CHELAN COUNTY NATURAL RESOURCE DEPARTMENT  
ICICLE CREEK STREAMBANK RESTORATION-RM 1.0

**ADDENDUM NO. 2**

**1. Revised Final Plans Set with Corrections to LWM Structure Log Schedule's**

CHECKED BY: SRSE  
 DESIGNED BY: DNH  
 DRAWN BY: DNH  
 FIRST SUBMITTAL DATE: 1/14/22  
 PROJECT NO. **CHEC00000020**  
 SHEET NO. **9** OF **18**  
**DT02**

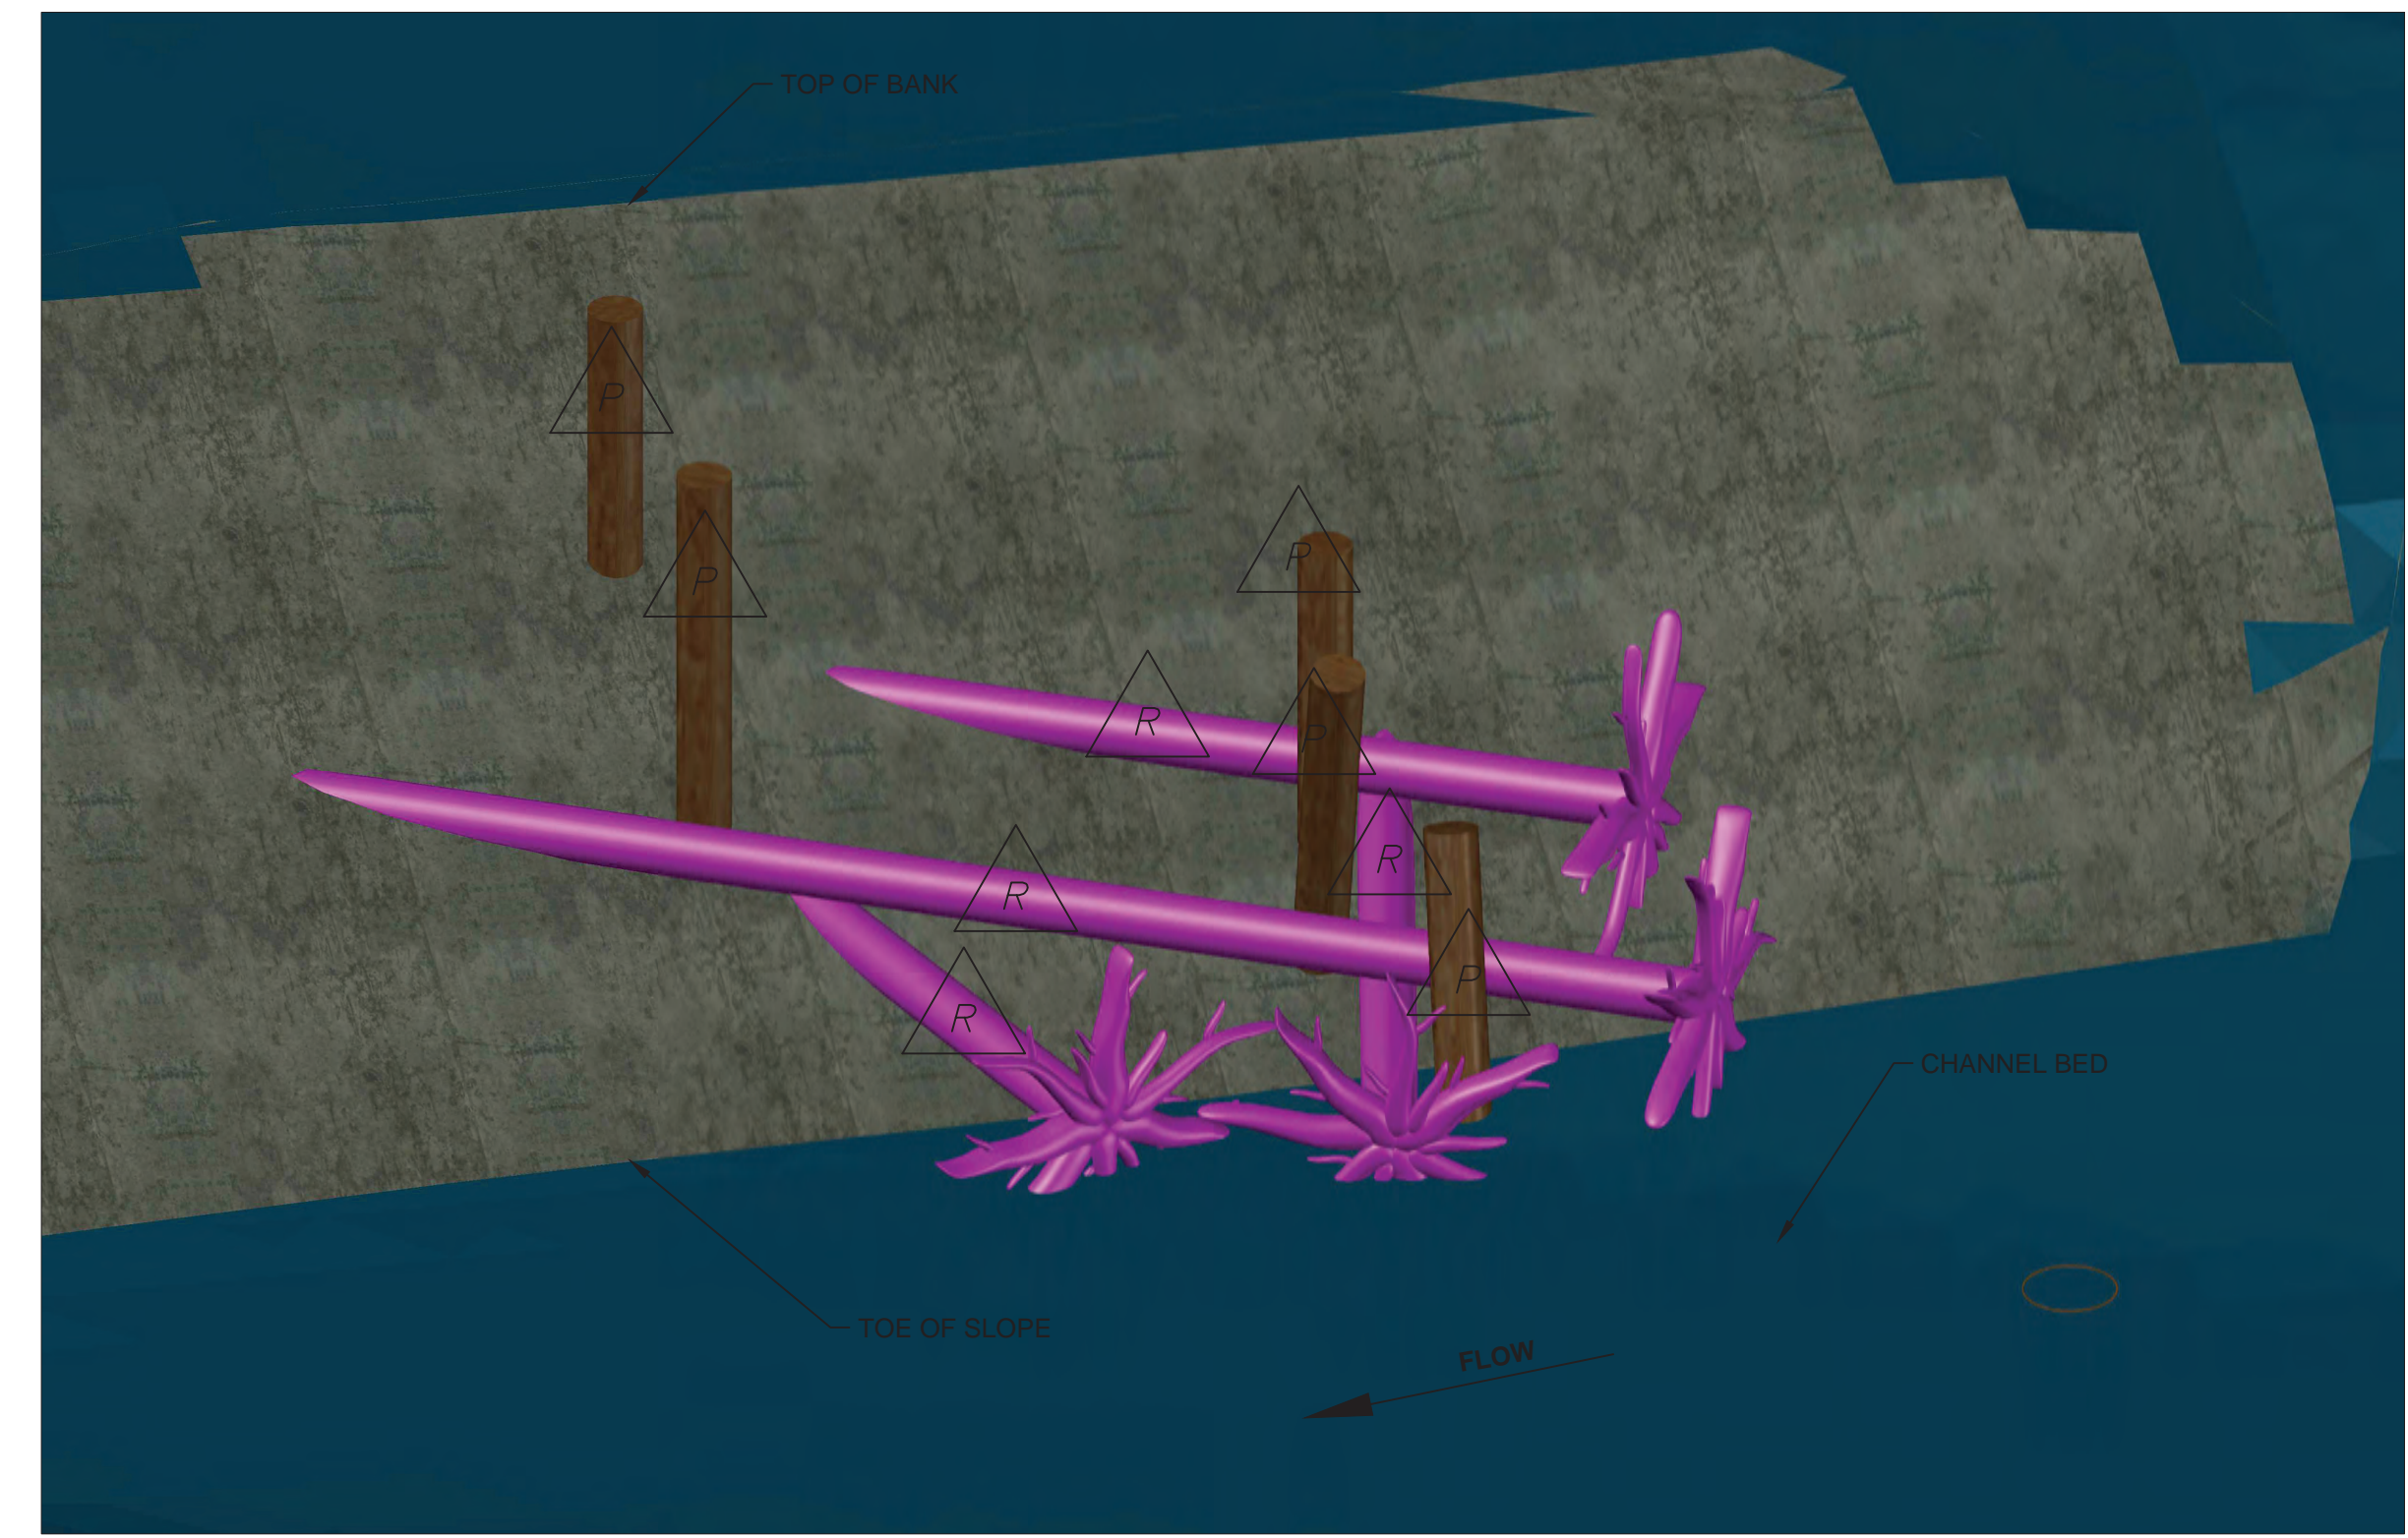
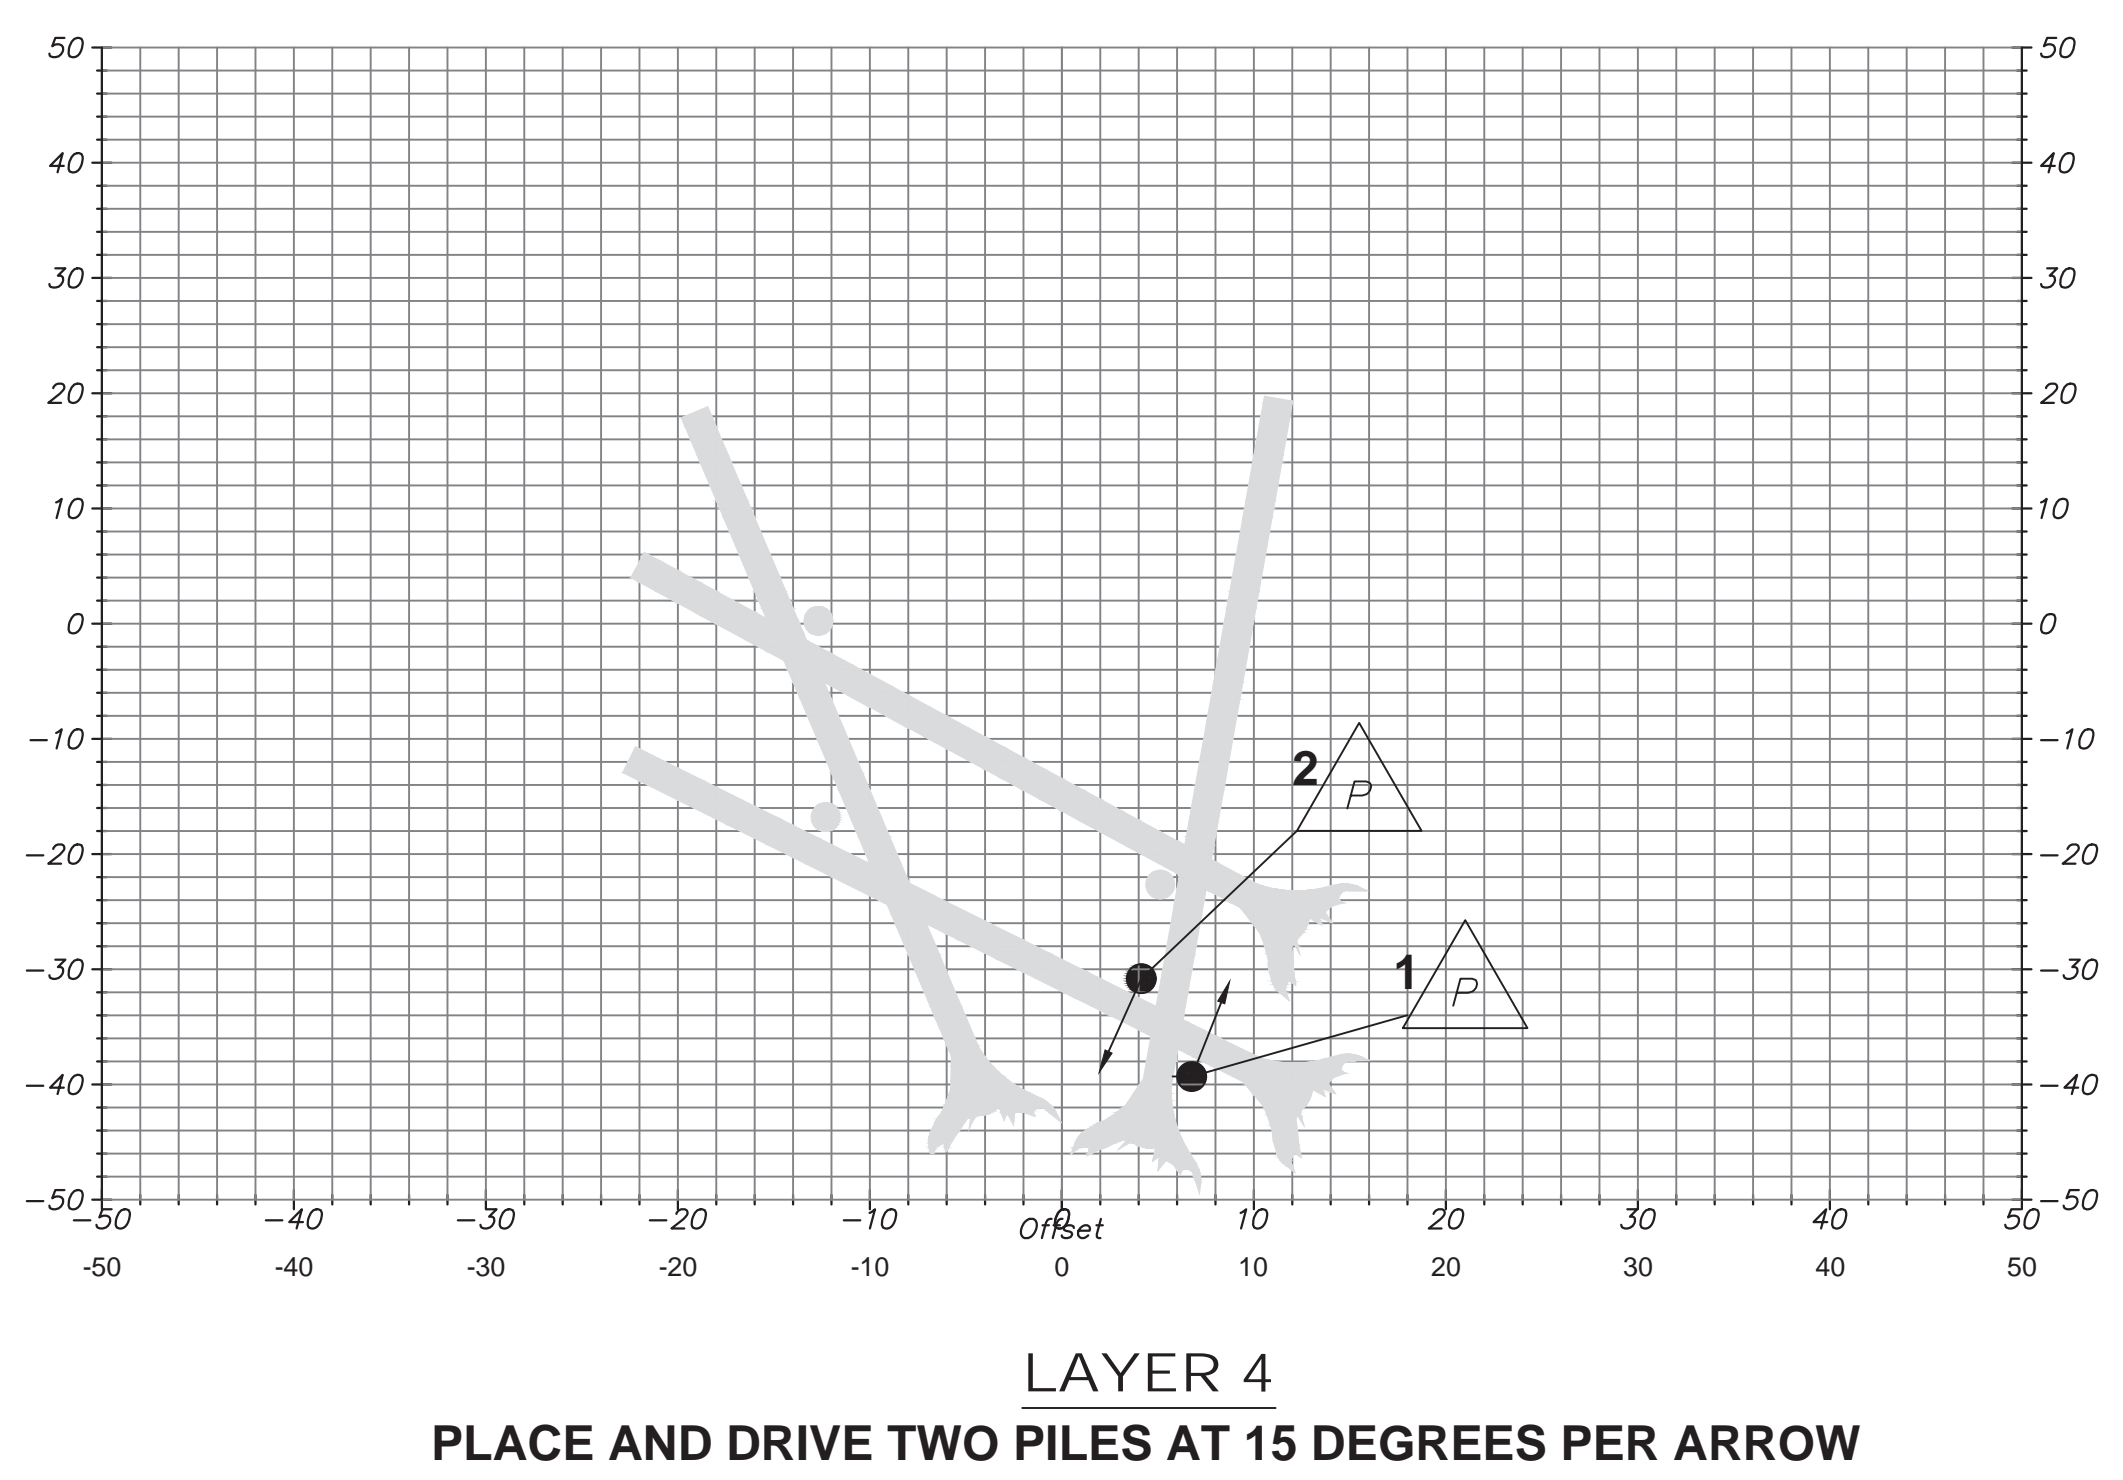
The "LWM Structure Log Schedule" on both sheets 9 (Type 1 LWM Structure) and 12 (Type 2 LWM Structure) have been corrected to show a pile length of 25' and dbh of 12"-15" as indicated in section 8-26.2(1) of the special provisions. The updated plans provided with this addendum are considered the new Final Plan set for this project.

DATE:	3/4/22	BY:	OK
NO.:	1	REVISION:	SS
3/4/22 corrected pile log diameter and length

LOG ID	COLOR	DIA. (INCHES)	LENGTH (FEET)	ROOTWAD (Y/N)	QUANTITIES PER STRUCTURE	NOTES
R	Blue	18	40	Y	4	
P	Red	18- 12 to 15	40 25	N	5
